R22 SERVICE BULLETIN SB-112

R44 SERVICE BULLETIN SB-94

SUBJECT: Actuator Lower Bearing A185 Brackets

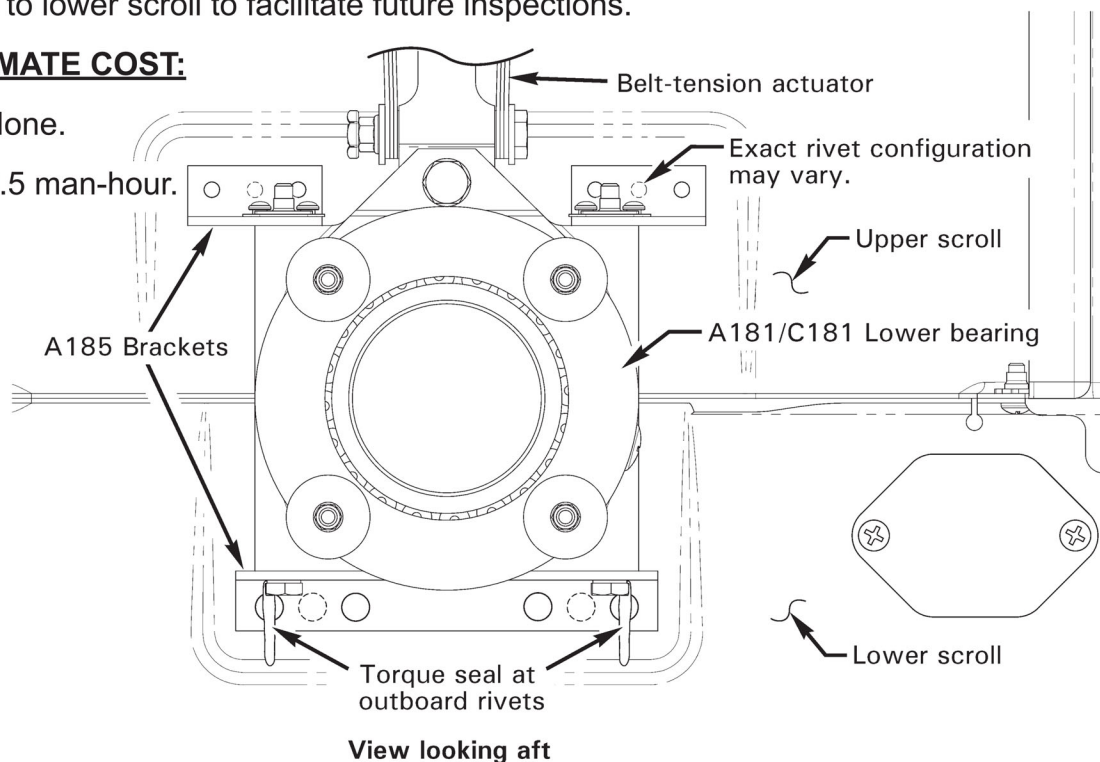
BACKGROUND: RHC has received reports of loose A185 brackets. Loose brackets may have allowed lower bearings to misalign resulting in belt-tension actuator damage.

1. Visually inspect A185 brackets and attaching rivets for evidence of fretting or looseness. If evidence of looseness is found, contact RHC Technical Support for repair instructions.
2. On lower A185 bracket, apply torque seal in a vertical stripe across both outboard rivets to lower scroll to facilitate future inspections.
